[Docket No. FAA-2022-1647; Project Identifier AD-2022-01379-T]

Airworthiness Directives; Transport and Commuter Category Airplanes

ACTION: Notice of proposed rulemaking (NPRM).

Figure 1 to paragraph (g)(2) – Effective Power Spectral Density

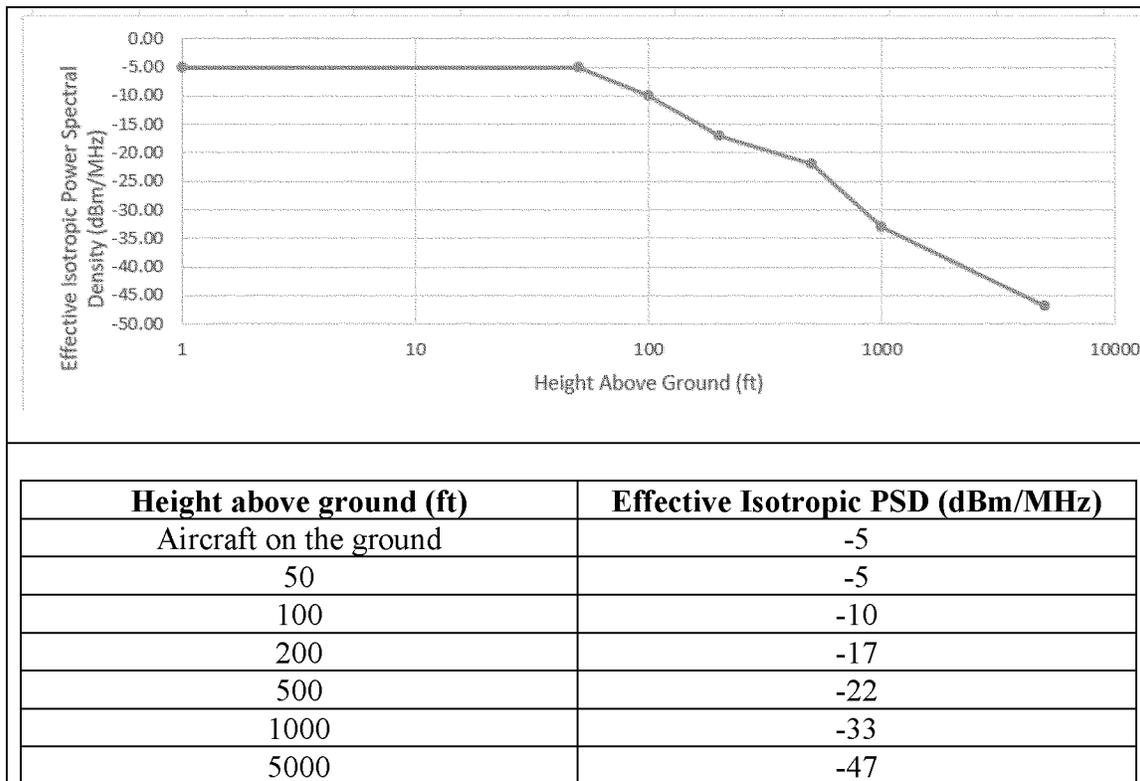
The interference tolerance requirements are represented by a power spectral density (PSD) curve. The PSD curve, as depicted in figure 1 to paragraph (g)(2) of this proposed AD, represents the height over the ground and received power from a 5G C-Band emitter, at or below which the radio altimeter is expected to function reliably, measured in decibels per megahertz. These measurements are limited to the 5G CMAs that will be listed in an FAA Domestic Notice. For purposes of this proposed AD, a “radio altimeter tolerant airplane” (also known within industry as a Group 4 airplane) is one for which the radio altimeter, as installed, demonstrates tolerance to radio altimeter interference at or above PSD curve threshold specified in figure 1 to paragraph (g)(2) of this proposed AD. A radio altimeter tolerant airplane also demonstrates tolerance to a spurious emission level of -48 dBm/MHz in the 4200–4400 MHz radio altimeter band. For purposes of this proposed AD, a “non-radio altimeter tolerant airplane” (also known in industry as a Group 1, 2, or 3 airplane) is one for which the radio altimeter, as installed, does not demonstrate those tolerances. Some radio altimeters may already demonstrate tolerance to the 5G C-Band emissions without modification. Some may need to install filters between the radio altimeter and antenna to increase a radio altimeter’s tolerance. For others, the addition of a filter will not be sufficient to address interference susceptibility; therefore, the radio altimeter will need to be replaced with an upgraded radio altimeter. The FAA has determined that radio altimeter tolerant airplanes will not experience the unsafe condition at any airport identified by the FAA as a 5G CMA in an FAA Domestic Notice.

(i) Tolerance to radio altimeter interference at or above the power spectral density (PSD) curve threshold specified in figure 1 to paragraph (g)(2) of this AD.

(ii) Tolerance to an aggregate base station conducted spurious emission level of -48 dBm/MHz in the 4200–4400 MHz radio altimeter band.
